FAQ 23-02 Peach Bottom
PI Interpretation Issue Request

Plant:	**Peach Bottom**		
Date of Event:	**5/16/22**		
Submittal Date:	**5/12/23**		
Licensee Contact:	**Wade Scott**	Tel/Email:	**717-456-3047 wade.scott@constellation.com**
NRC Contact:	**Scott Rutenkroger**	Tel/Email:	**717-456-3313 Scott.Rutenkroger@nrc.gov**

Performance Indicator: Unplanned Scrams with Complications

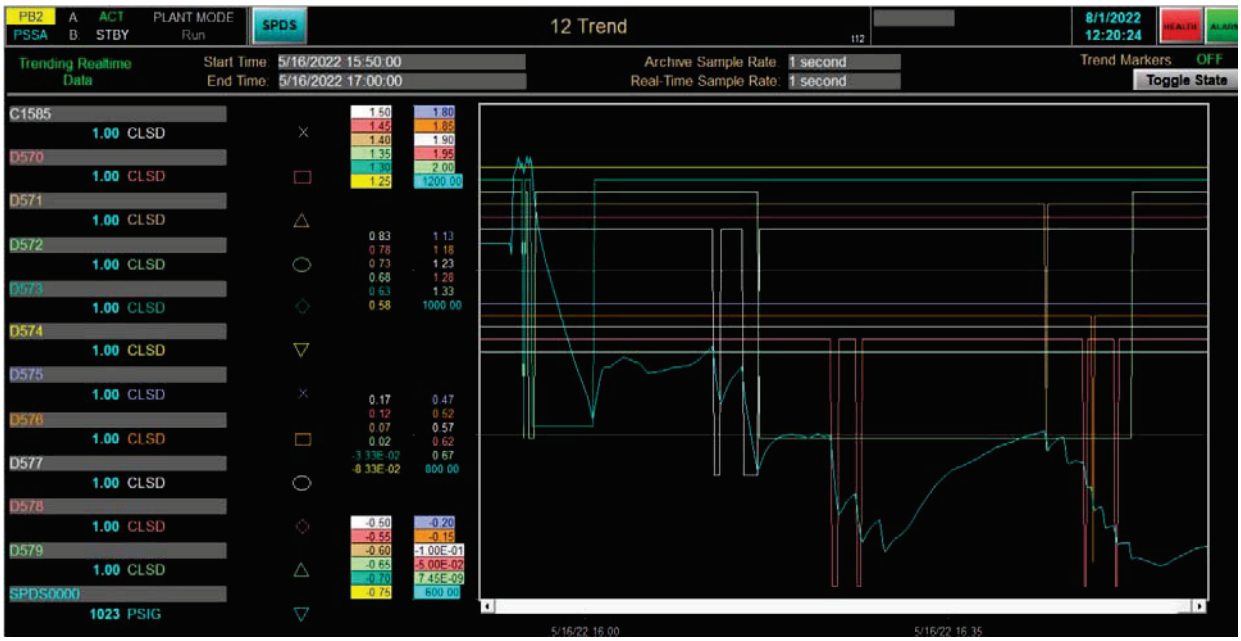
NRC Position for Question 2:
This guidance first describes the usage of SRVs and states that reactor pressure must be controlled following the initial transient without their use. The guidance then expounds by providing a distinction between initial transient automatic cycling versus automatic cycling, subsequent to the initial transient. This guidance appears based on typical BWR post-scram pressure response given a scram at higher power levels with closure of the main steam isolation valves (MSIVs), which necessarily includes a brief period of automatic cycling of SRVs. It directly compares initial automatic to subsequent automatic operation. In particular, the guidance does not then make a distinction between subsequent automatic cycling versus subsequent manual cycling. As such, the inspectors determined that this guidance is intended to make a distinction between the use, or not, of SRVs following an initial transient, regardless of whether such use was automatic or manual and regardless of whether such usage was required to maintain pressure or reduce pressure further. To restate, the distinction is solely whether or not SRVS were cycled after the brief, initial pressure transient.

The inspectors reviewed the plant computer data and determined the SRV cycling which took place within the first few minutes of the scram (15:53:04 to 15:55:13) qualified as “occurred as a result of the initial transient.” After this period, pressure control was maintained by manual cycling of SRVs and by using HPCI in CST-to-CST mode. Following the first few minutes, the operators initially dropped pressure to about 830 psig in 10 minutes. The operators then maintained reactor pressure up to 900 psig for 10 minutes (i.e. 20 minutes post-event). Operators then lowered pressure down to 660 psig between 20 minutes and 40 minutes post-event. Operators then allowed the pressure to rise to 800 psig. Operators then reduced the pressure from 800 psig back to 650 psig from about 50 minutes to 60 minutes post-event. Operators then, at approximately 90 minutes post-event, began reducing pressure further, lowering pressure to below 600 psig approximately two hours post-event. The inspectors counted ten SRV cycles between 20 minutes and 60 minutes post-event when the reactor pressure was maintained between 900 psig and 650 psig.

Therefore, during this event, SRVs lifted as expected during the initial transient (a few minutes or less) to mitigate the rise in reactor pressure. Then, there were additional SRV actuations beyond the initial transient (in this case beyond 20 minutes) and the question should be answered “Yes” absent an approved FAQ stating otherwise.
